# TECHNICAL EVALUATION REPORT

## EVALUATION OF SPENT FUEL RACKS STRUCTURAL ANALYSIS

ROCHESTER GAS AND ELECTRIC CORPORATION  
R. E. GINNA NUCLEAR POWER PLANT

NRC DOCKET NO. 50-244

Figure 1. Pool Layout

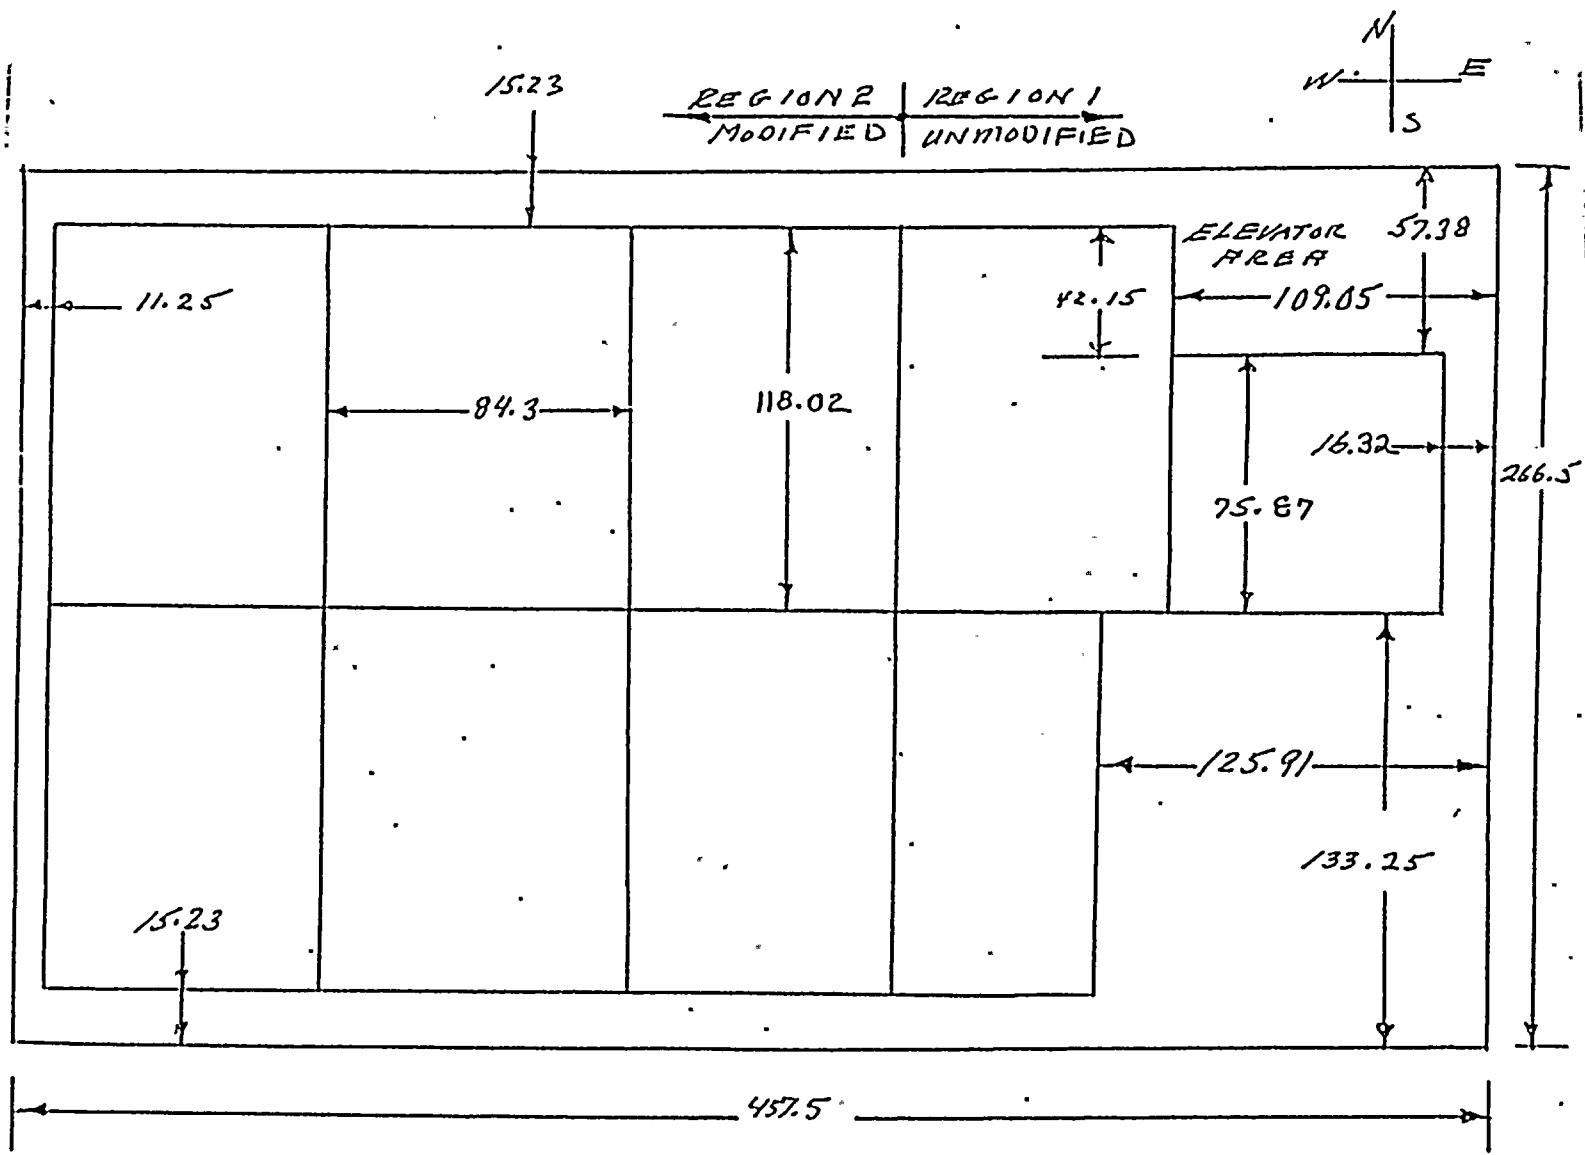
Only the six modules in Region 2, shown in Figure 1, are subjected to rerack modification [1]. All of these modules have identical cross-sectional dimensions, 84.3 in x 118.02 in. Modules having this design of nearly square cross sections generally behave in three-dimensional fashion in seismic events. Hence, the modules will exhibit three-dimensional nonlinear structural behavior under earthquake loadings, and all seismic analyses of modules should therefore focus on characterizing this behavior.

The pool layout shown in Figure 1 indicated that there is no gap between adjacent modules in the pool. The Licensee stated that, because of the strong hydrodynamic coupling effects in the case of no gap, adjacent modules were forced to vibrate in phase, thus precluding any impact between adjacent

modules [5]. This claim is generally true for identically loaded modules, but out-of-phase vibration will most likely occur when the modules are loaded in different patterns, either empty, partially, or fully loaded. The out-of-phase motion will probably result in some form of impact between adjacent modules. In light of this probability, an impact analysis is needed in order to demonstrate that the impact does not cause any damage to the module structure or its contents [2].

The Licensee responded [5] by performing an impact analysis. The RACKOE model shown in Figure 2 was modified to include the compression-only springs at the top of the module to represent the presence of the adjacent module. The compressive force obtained in these springs was used to calculate the impact area on the wall of fuel cells based on the allowable compressive stress requirement. The length of wall required to resist the compressive force was calculated to be 16.0 inches in the east-west direction and 16.9 inches in the north-south direction. These impact wall lengths are acceptable since there is not much space between adjacent modules. The Licensee also demonstrated that the impact between adjacent modules would not adversely affect the stress distribution within the module structure [6].

Figure 2. RACKOE Model of Spent Fuel Racks

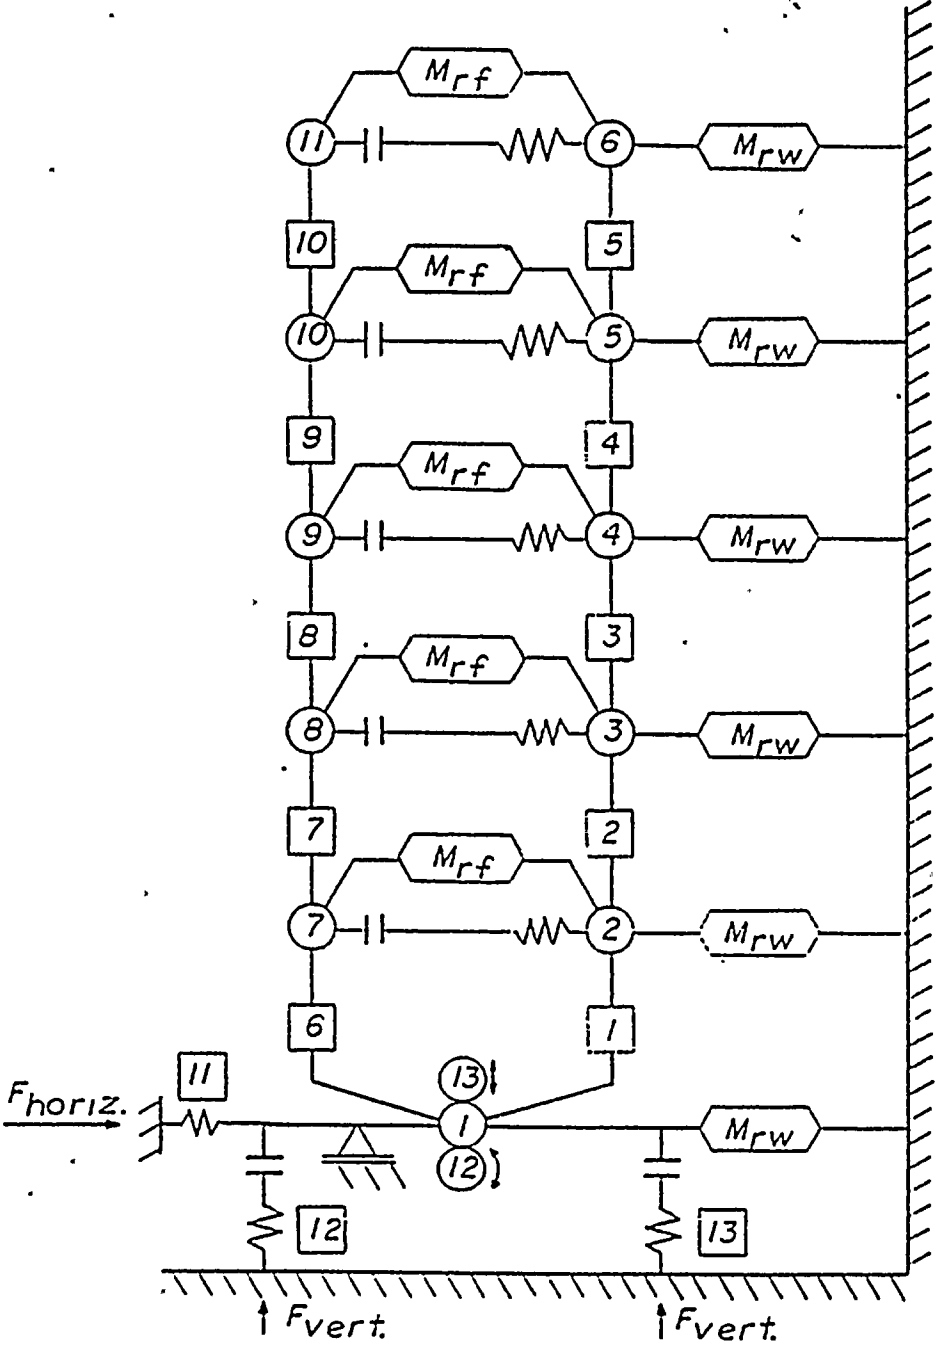
A two-dimensional nonlinear model was developed in accordance with the special purpose finite element program, RACKOE. This program was designed to solve the equations of motion explicitly using Euler's extrapolation formula. A schematic view of the RACKOE model is shown in Figure 2.

The masses of the fuel cells and fuel assemblies are discretized in the RACKOE model. There are six concentrated mass nodes used to represent the fuel cells, with one node at the base of the module and the other five nodes at equal distance along the fuel cells. The nodes are linked by flexible elements. Similar arrangements are made to simulate fuel assemblies at five mass nodes. The mass nodes of fuel cells and fuel assemblies are connected via (1) gap elements, to simulate impact between them, and (2) hydrodynamic masses, to represent hydrodynamic coupling between them. The friction between the module and the pool support stand is handled by friction elements which can only carry compressive loads. A horizontal spring is also used to represent frictional resistance of the module against sliding.

The assumption in Item c may be valid when adjacent modules are identically loaded, but an out-of-phase response will most likely occur for differently loaded modules, either empty, partially, or fully loaded.

Figure 3. Simplified RACKOE Model for Liftoff Analysis

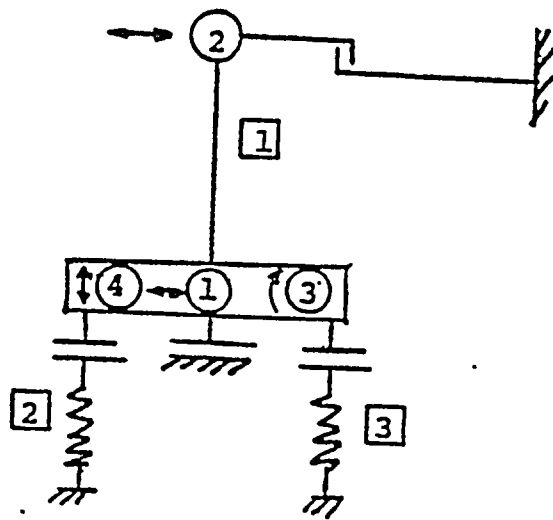
structure. A modified RACKOE model, shown in Figure 3, was used in this analysis [8]. This simplified model used a single mass to simulate the module and its contents. This approach basically assumes a stiff beam to represent the entire module. This assumption is reasonably valid because the module is very stiff in the vertical direction. Furthermore, the Licensee demonstrated that identical results were obtained from a model containing five concentrated mass nodes to represent the module structure and its contents [6].
